RA6M3 Group

Evaluation Kit for RA6M3 Microcontroller Group
EK-RA6M3 v1
Errata

EK-RA6M3 v1 – Errata

Figure 2. Package Type on Silk Screen

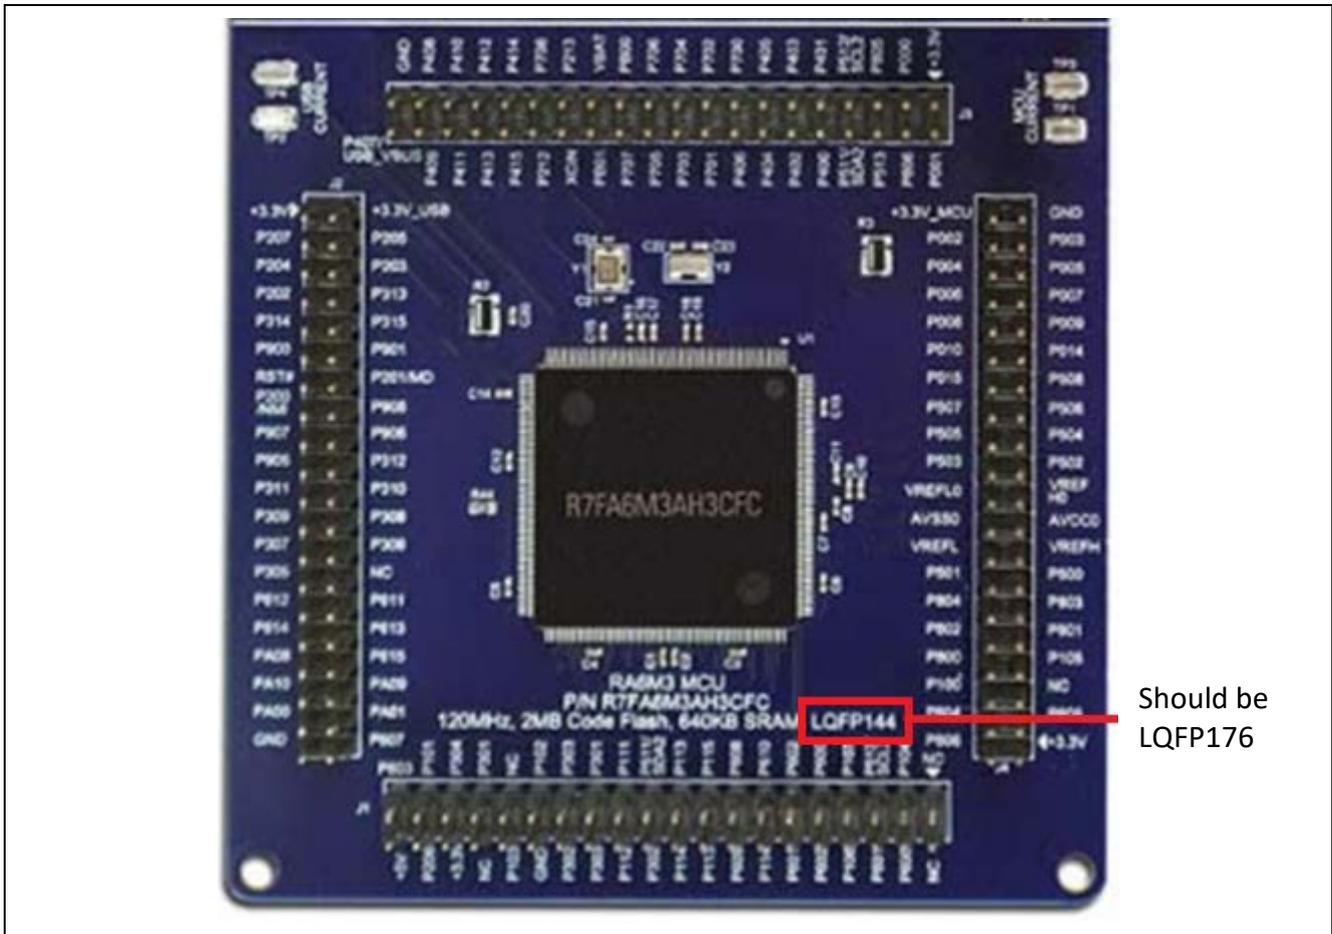
The silk screen on the EK-RA6M3 board shows an incorrect package type for the RA6M3 MCU. The incorrect silk screen identifies the package type as LQFP144. The actual package type is LQFP176.

No corrective action is needed. The silk screen is correct on later builds of the board.

Figure 3. P105 Rework Pin Locations

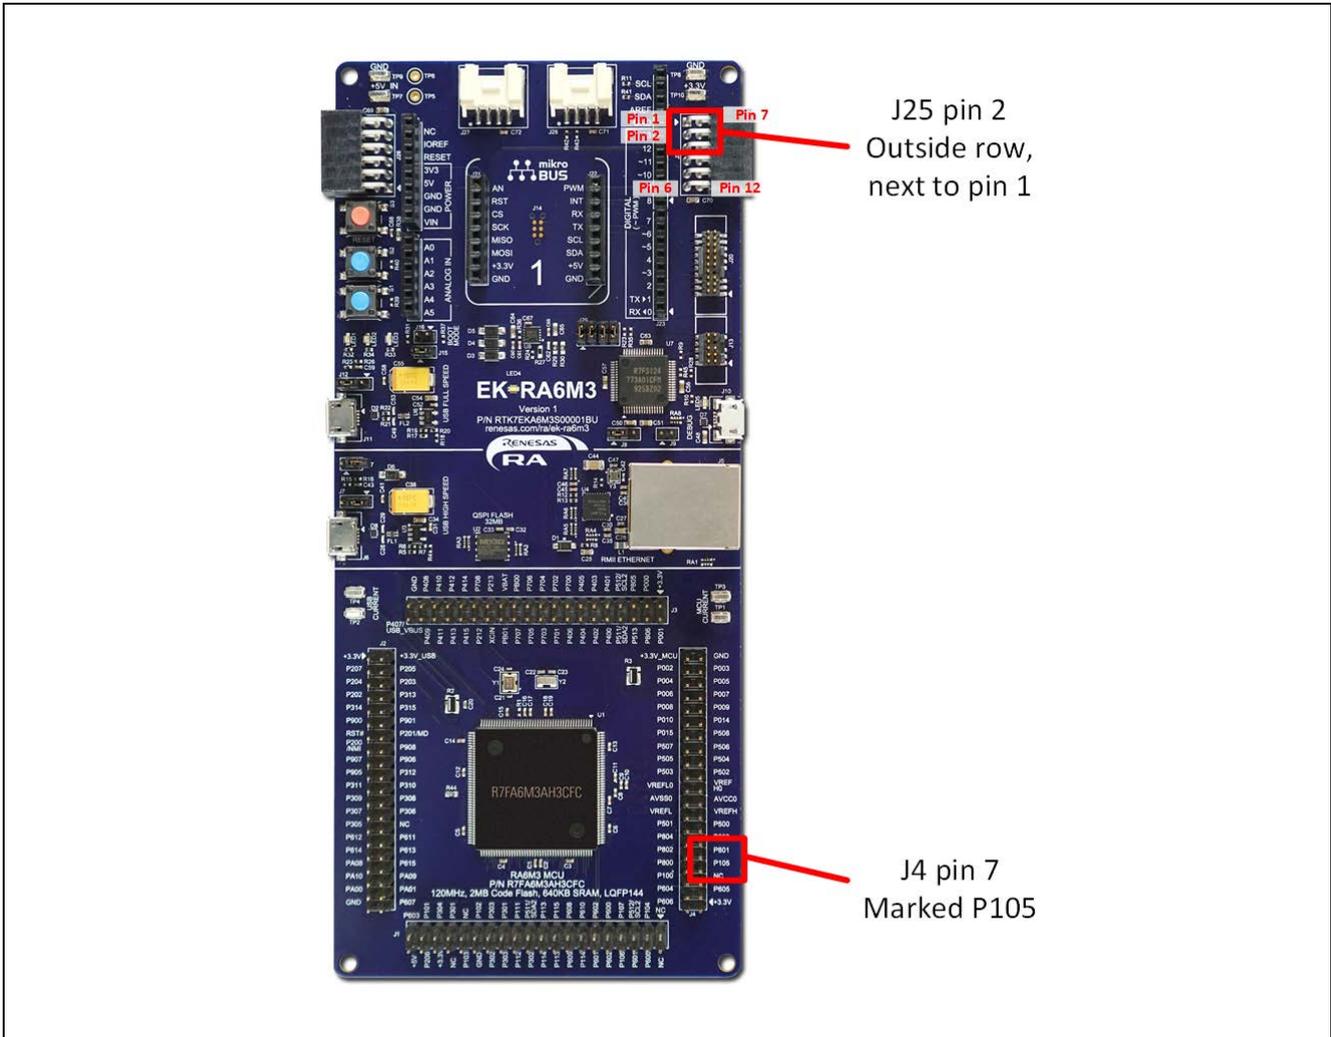
P105 is not connected between J4 pin 7 and J25 pin 2. As a result, PMOD 2 may not function correctly.

A wire may be added between J4 pin 7 and J25 pin 2. This will add the correct functionality to PMOD 2. It is recommended to add rework wire on the bottom side of the board.

This error has been corrected on later builds of the board.

Figure 4. USB Full Speed Rework Locations

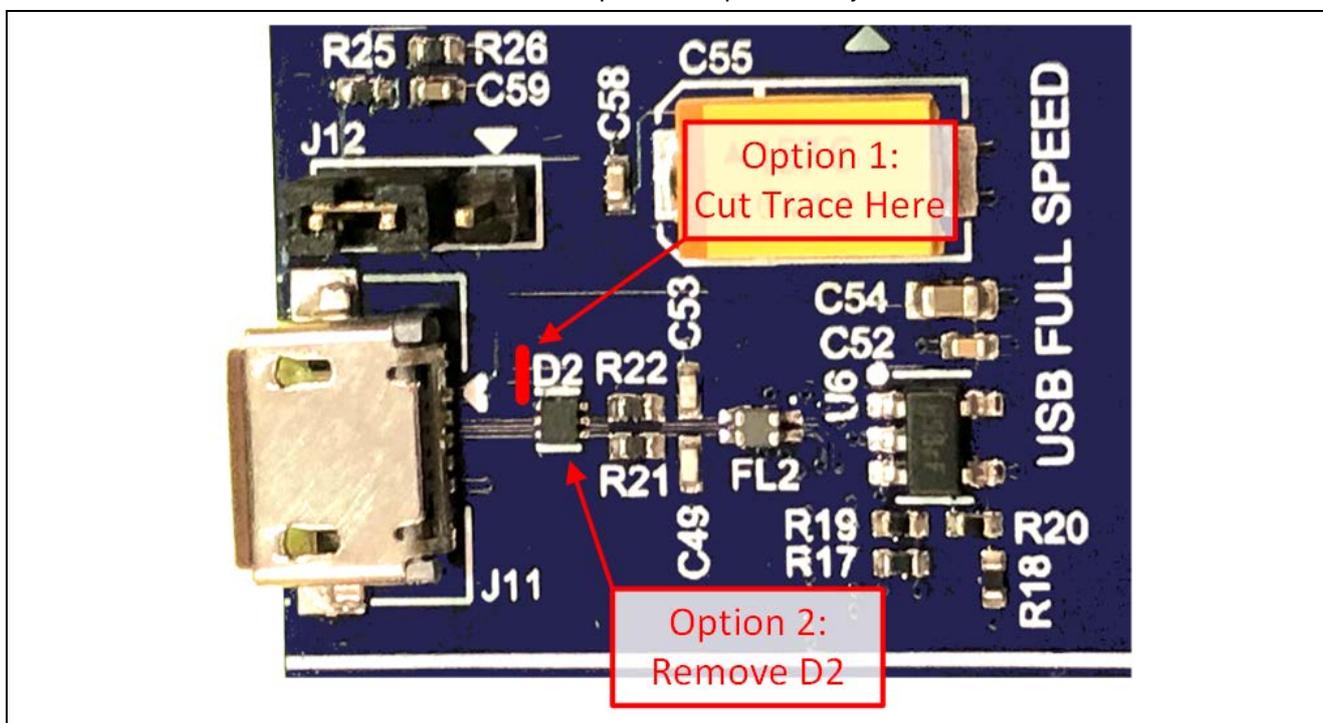
When configured in Device Mode, the USB Full Speed peripheral in the RA6M3 MCU uses the USB_VBUS signal (P407) to detect the presence of a USB cable connected to J11. Due to voltage leakage through the ESD protection circuit D2, the voltage on P407/USB_VBUS may not drop low enough to detect detaching a cable at J11. This may prevent the USB Full Speed port from detecting that cable has been disconnected. The issue occurs when a cable is first connected to the USB port and is properly configured, then the cable is disconnected.

There are two possible methods to enable correct operation of the USB Full Speed port in self-powered mode. Implementing either method will resolve the issue. It is not necessary to implement both methods.

1. (Recommended) Cut the +5V trace between D2 pin 6 and the rest of the USB Full Speed +5V trace. Cut the trace at the location indicated by the arrow in Figure 4. The trace is located next to the D2 reference designator on the top side of the circuit board.
2. Remove D2. This will eliminate the voltage leakage between the USB Full Speed data lines and the USB +5V. However, this will also remove the ESD protection provided by D2.

Figure 5. USB High Speed Rework Locations

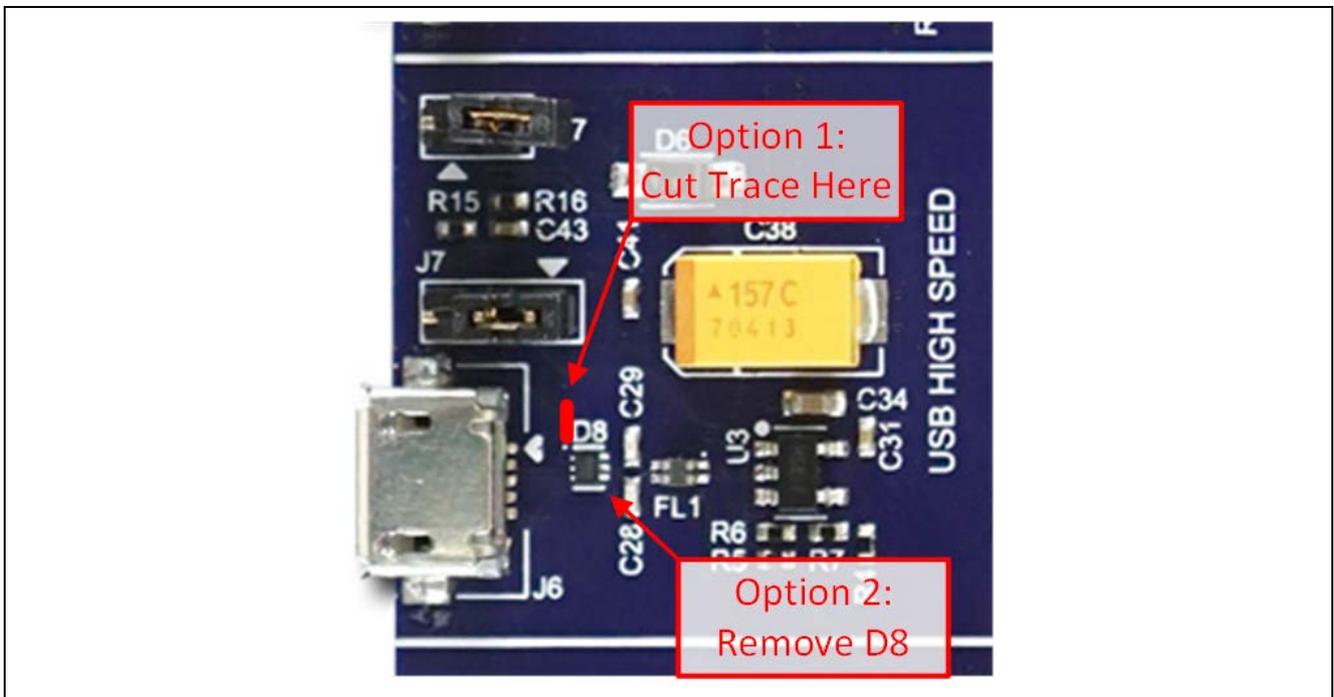
When configured in Device mode, the USB High Speed peripheral in the RA6M3 MCU uses the USBHS_VBUS signal (PB01) to detect the presence of a USB cable connected to J6. Due to voltage leakage through the ESD protection circuit D2, the voltage on PB01/USBHS_VBUS may not drop low enough to detect detaching a cable at J6. This may prevent the USB High Speed port from detecting that the cable has been disconnected. The issue occurs when a cable is first connected to the USB port and is properly configured, then the cable is disconnected.

There are two possible methods to enable correct operation of the USB Full Speed port in self-powered mode. Implementing either method will resolve the issue. It is not necessary to implement both methods.

1. (Recommended) Cut the +5V trace between D8 pin 6 and the rest of the USB High Speed +5V trace. Cut the trace at the location indicated in Figure 5. The trace is located next to the D8 reference designator on the top side of the circuit board.
2. Remove D8. This will eliminate the voltage leakage between the USB High Speed data lines and the USB +5V. However, this will also remove the ESD protection provided by D8.
